Model: Model K-P2	Date: 4-Jun-02	No.: RG073001a
-------------------	----------------	----------------

Subject: Printer Controller Firmware History		Prepared by: A. Ishiyama	
From: Technical Services sec. Service Planning Dept.			
Classification:	<input type="checkbox"/> Troubleshooting <input type="checkbox"/> Mechanical <input type="checkbox"/> Paper path <input type="checkbox"/> Other (      )	<input type="checkbox"/> Part information <input type="checkbox"/> Electrical <input type="checkbox"/> Transmit/receive	<input checked="" type="checkbox"/> Action required <input type="checkbox"/> Service manual revision <input type="checkbox"/> Retrofit information

Printer controller firmware history for the Model K-P2 (Kir-P2: G073/G074 model).

## User Mode Tree

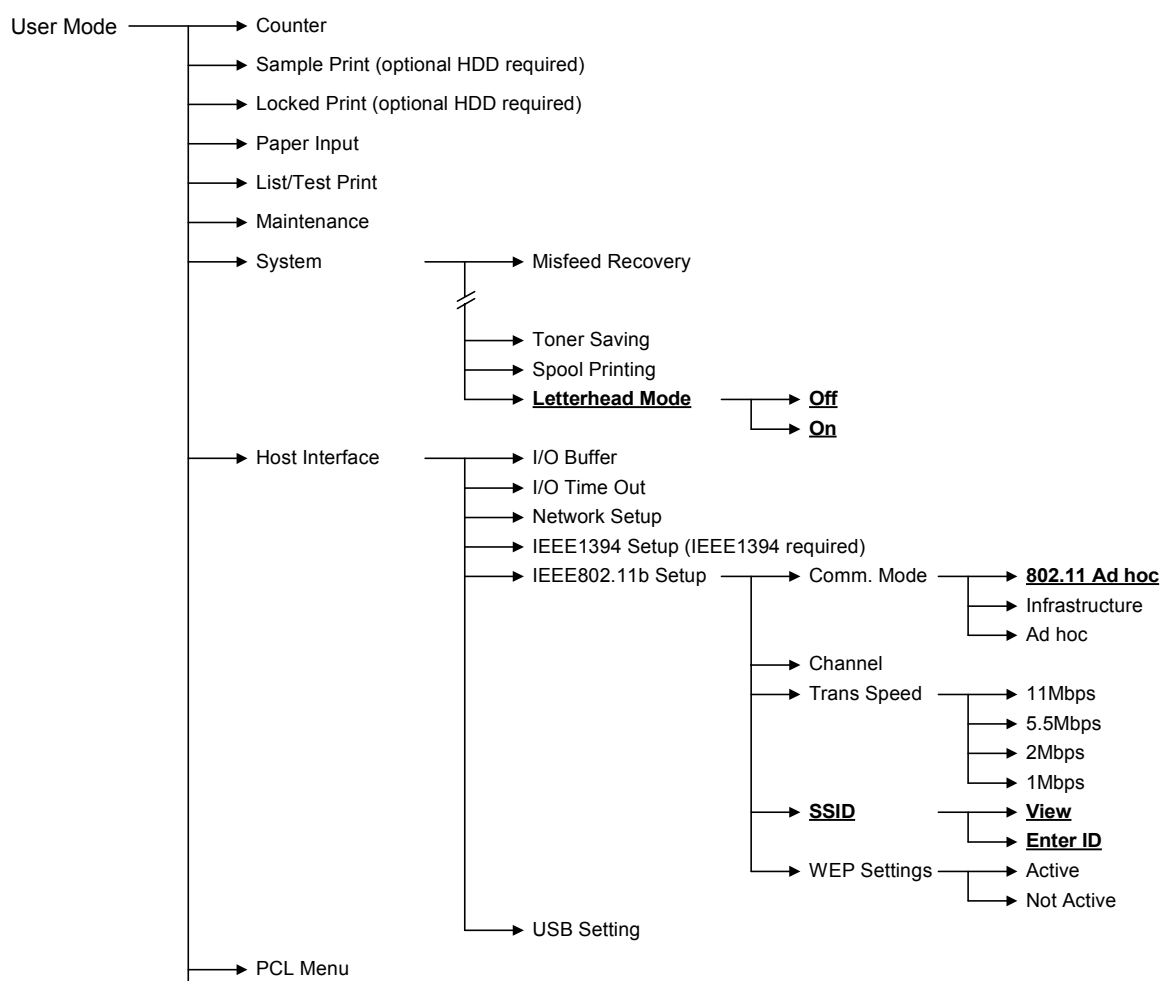
Descriptions	Version
<p><i>Firmware modified to correct the following:</i></p> <ol style="list-style-type: none"> <li><b>SNMP vulnerability</b>  <i>SNMP security vulnerabilities reported by CERT on Feb.12, 2002 have been confirmed and fixed through the PROTON c06-snmpv1 test suite.</i>            -CERT: <a href="http://www.cert.org/advisories/CA-2002-03.html">http://www.cert.org/advisories/CA-2002-03.html</a>            -PROTON c06-snmpv1 test Suite:  <a href="http://www.ee.oulu.fi/research/ouspg/protos/testing/c06/snmpv1/">http://www.ee.oulu.fi/research/ouspg/protos/testing/c06/snmpv1/</a> </li> </ol> <p><b>New features added to User Mode (see the next page for the User Mode tree):</b></p> <ol style="list-style-type: none"> <li><b>Letterhead Mode</b>  <b>On:</b> The machine feeds all pages through the duplex unit so that the last page of a job with an odd number of pages is printed onto the front side of the paper.   <b>Off (default setting):</b> The last sheet of a job with an odd number of pages is not fed through the duplex unit. Therefore, although the output time of this sheet is slightly faster, the last page is printed onto the rear side.         </li> <li><b>802.11 Ad hoc mode</b> (one type of Ad hoc mode used with wireless LAN) is supported from this version.</li> <li><b>SSID</b> (used for infrastructure mode with wireless LAN) can now be programmed from User Mode as well – previously, this was only possible using Web Status Monitor or telnet.</li> <li><b>128-bit WEP key</b> (a wireless LAN security feature) is supported from this version. Previous versions supported only 64-bit WEP.</li> </ol>	<b>1.04</b>

Underlined features have been added from version 1.04.

## User Mode Tree

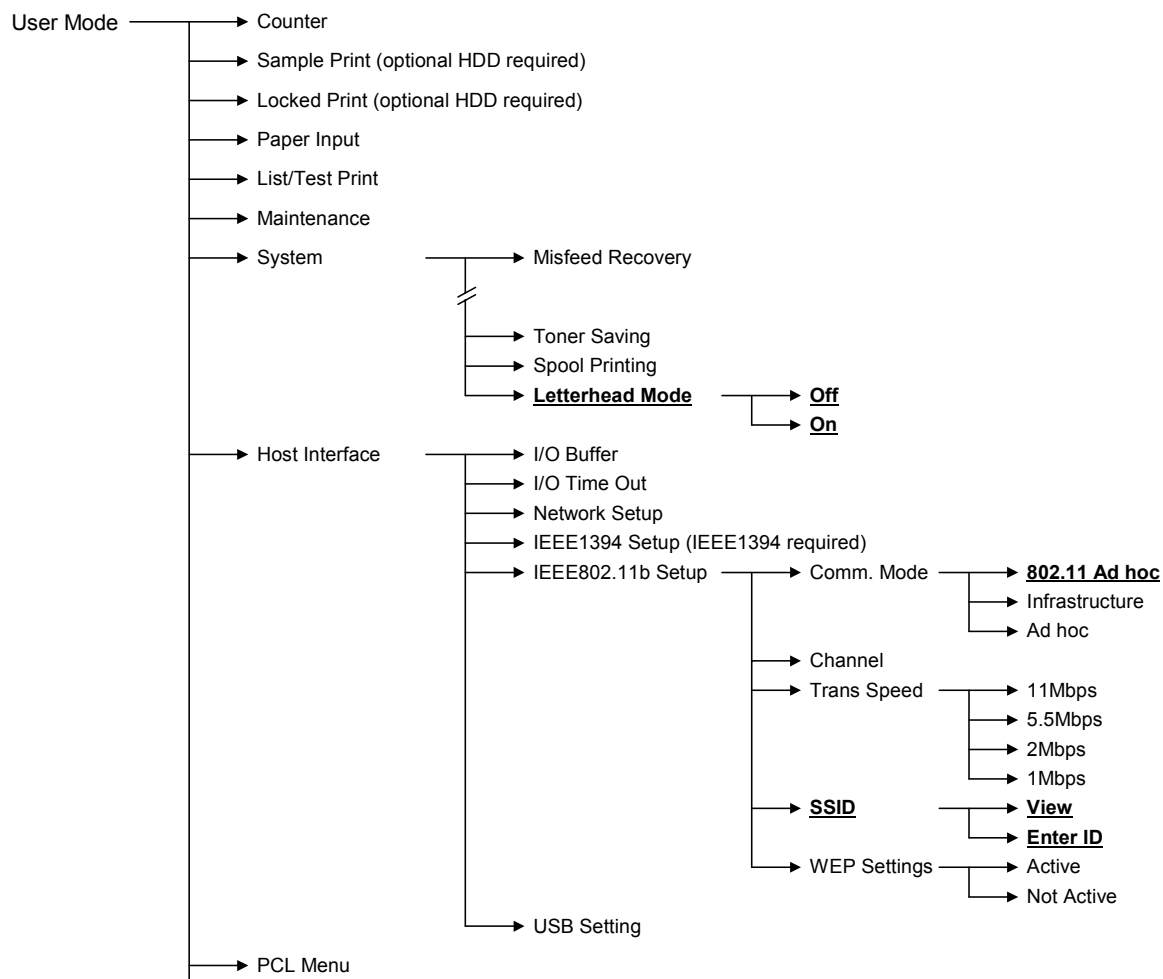
Underlined features have been added from version 1.04.

## User Mode Tree

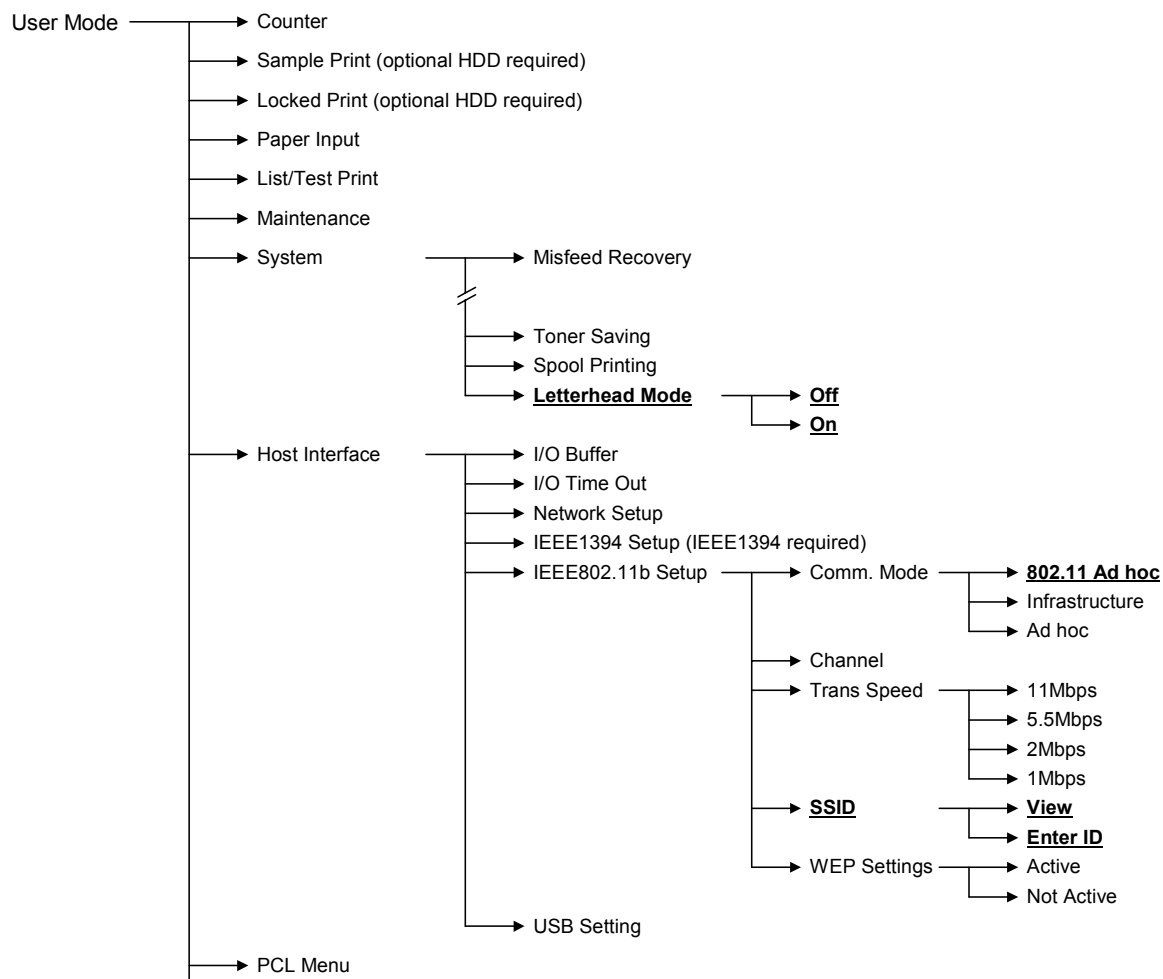
Underlined features have been added from version 1.04.

## User Mode Tree

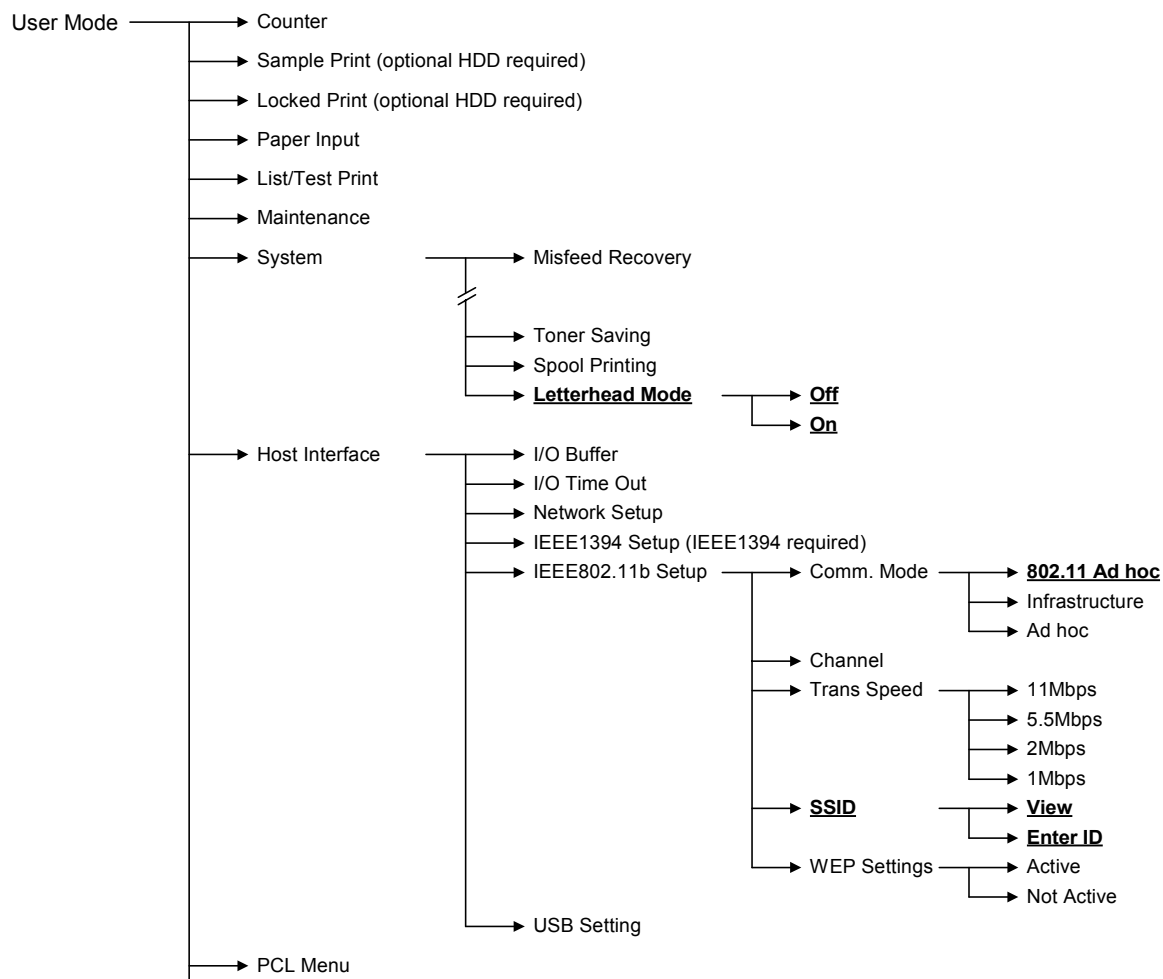
Underlined features have been added from version 1.04.

## User Mode Tree

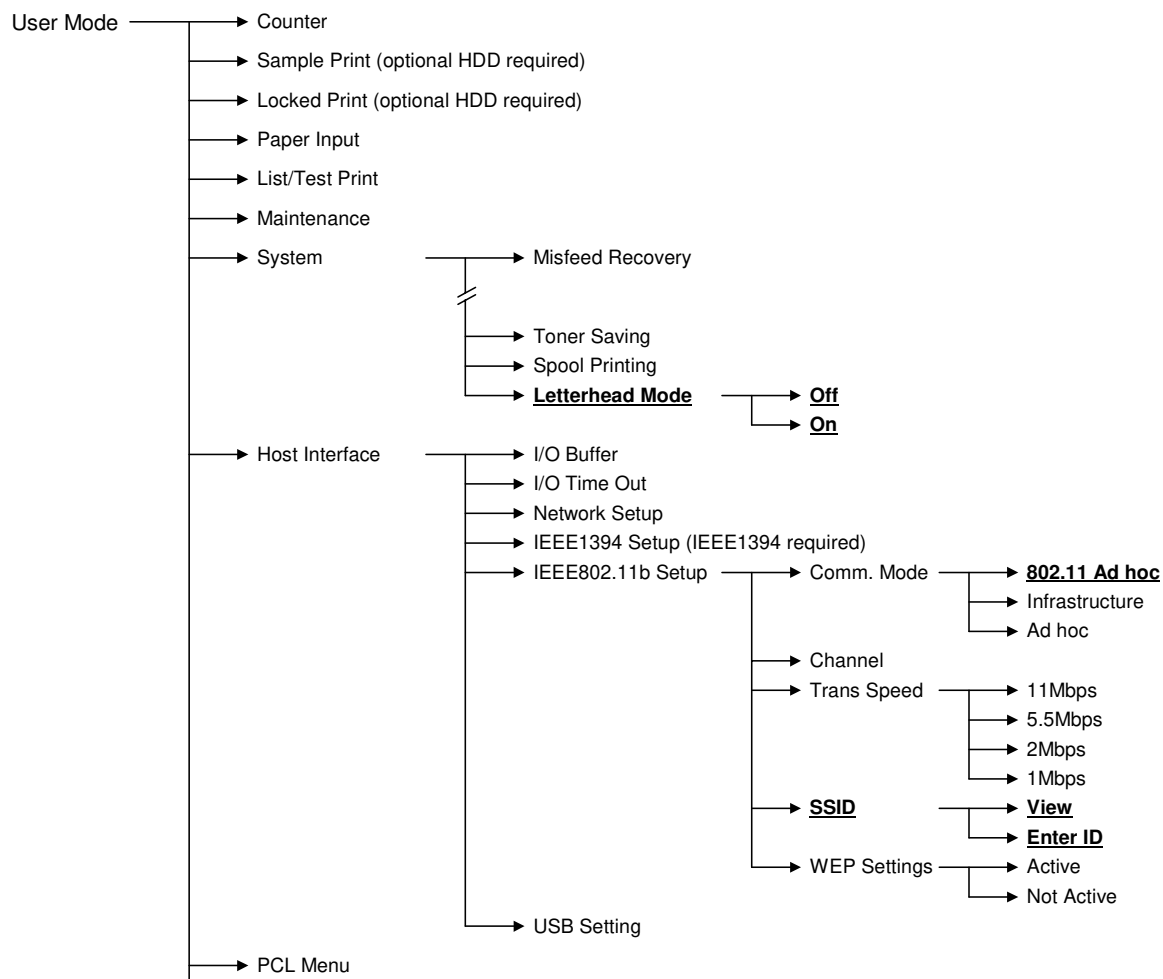
<p><b>New features added to User Mode (see next page for User Mode tree):</b></p> <ol style="list-style-type: none"> <li>1. <b>Letterhead Mode</b> <b>On:</b> The machine feeds all pages through the duplex unit so that the last page of an odd-paged job is printed onto the front side of the paper.  <b>Off</b> (default setting): The last sheet of an odd-paged job is not fed through the duplex unit, therefore although the output time of this sheet is slightly faster, the last page is printed onto the rear side.</li> <li>2. <b>802.11 Ad hoc mode</b> (one type of Ad hoc mode used with wireless LAN) is supported from this version.</li> <li>3. <b>SSID</b> (used for infrastructure mode with wireless LAN) can now also be programmed from User Mode. Previously, this was only possible using Web Status Monitor or telnet.</li> <li>4. <b>128-bit WEP key</b> (a wireless LAN security feature) is supported from this version. Previous versions supported only 64-bit WEP.</li> </ol>		1.04

Underlined features have been added from version 1.04.
